Modjeski and Masters Evaluation of Docket Items from Louis Berger

Miami, FL

HWY18MH009

RE: PN3897
FIU Bridge Collapse
Review of NTSB Information

Figure 1. Excerpt from FIGG's calculations (FIU_0000000045 page 1398)

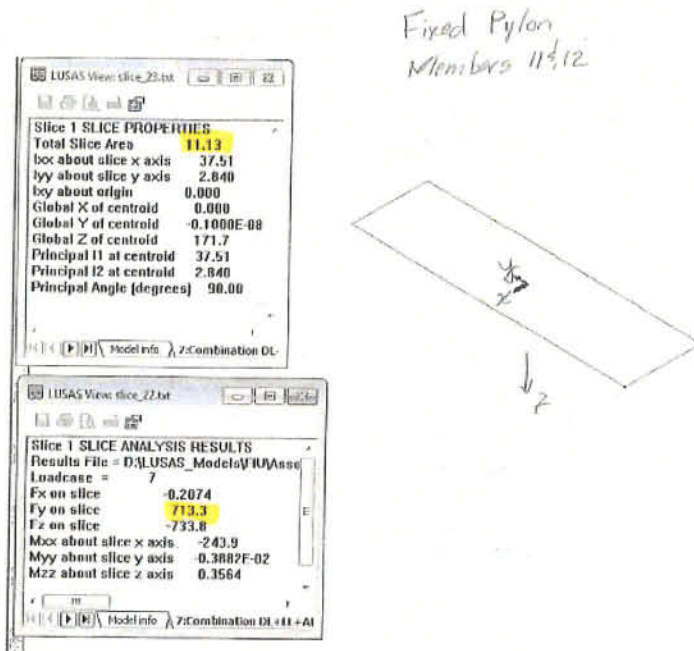
M&M was able to identify the specific model that FIGG used to extract the interface shear forces of the nodal region 11-12 (FIGG278027, see Figures 1 and 2). It was verified that this model has a coarse mesh, especially at the nodal regions (Figure 3), and uses linear solid elements instead of the enhanced quadratic elements. FIGG’s original model was modified by M&M as part of the investigation in order to evaluate the effects of the mesh density and the location of the slice plane on the automatically generated LUSAS forces. Figure 4 shows that changing the element formulation from linear to quadratic is more effective than decreasing the size of linear elements. On the other hand, Figure 5 indicates that the issue of inaccurate integration results practically disappears by moving the slice plane a minor distance from the deck within the truss elements.

Figure 4. Mesh density effect on interface shear demands

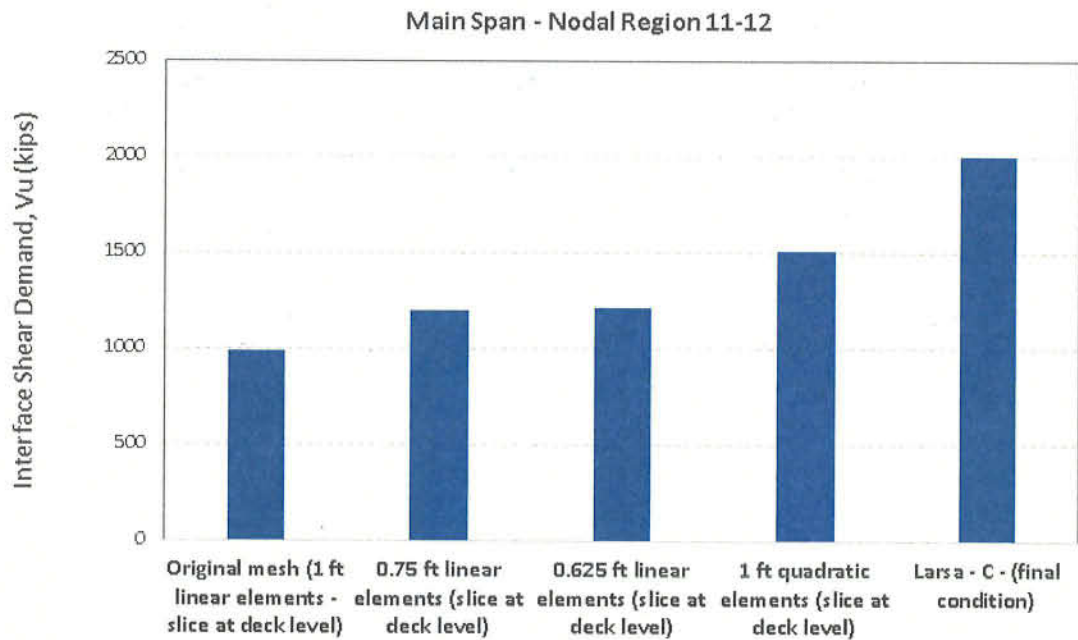
Thus, despite being aware of potential inaccuracies in the use of a model with a coarse mesh, FIGG proceeded to use their original design forces without verifying the results were accurate and despite the guidance and advice provided by the software supplier.

Figure 5. Slice location effect on interface shear demands

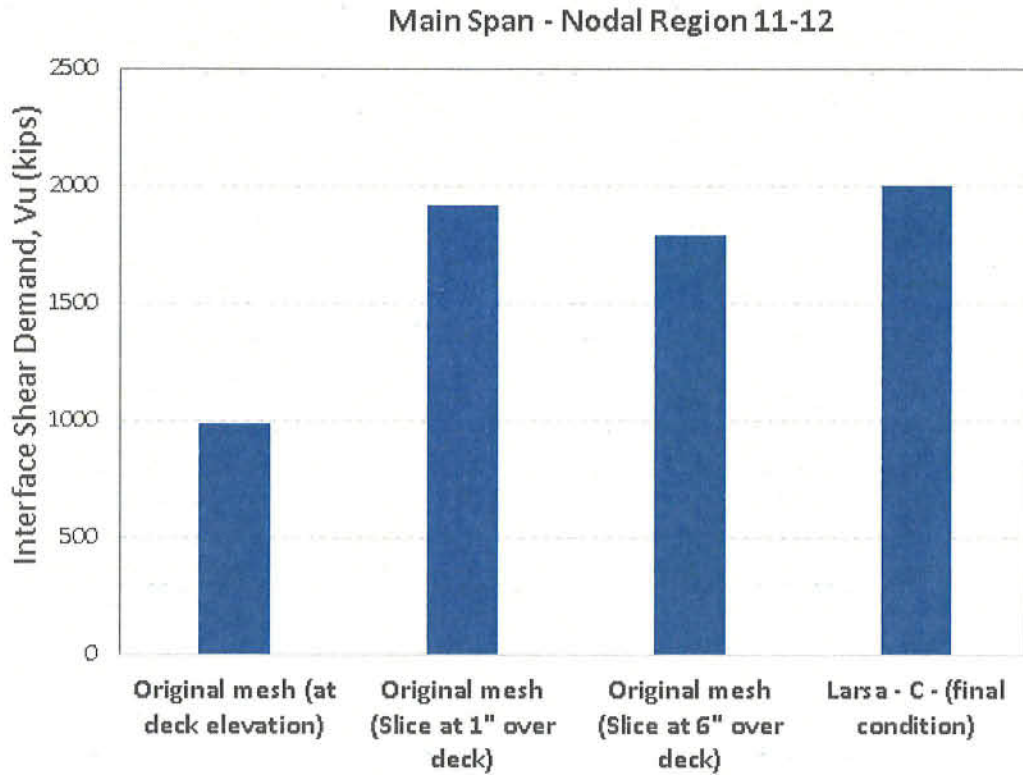
FIGG did not appear to have correctly utilized the slice function, since the model was cut right at the interface between the truss elements and the deck (or canopy). This can result in inaccurate results, particularly if only one side of the interface is active when the slice is taken. It appears likely that FIGG applied the slicing function at the interface with only one side active, and therefore did not obtain accurate results. The slices are usually taken within the element boundaries to avoid this issue. MCM’s investigation of the collapse also addressed this problem.³
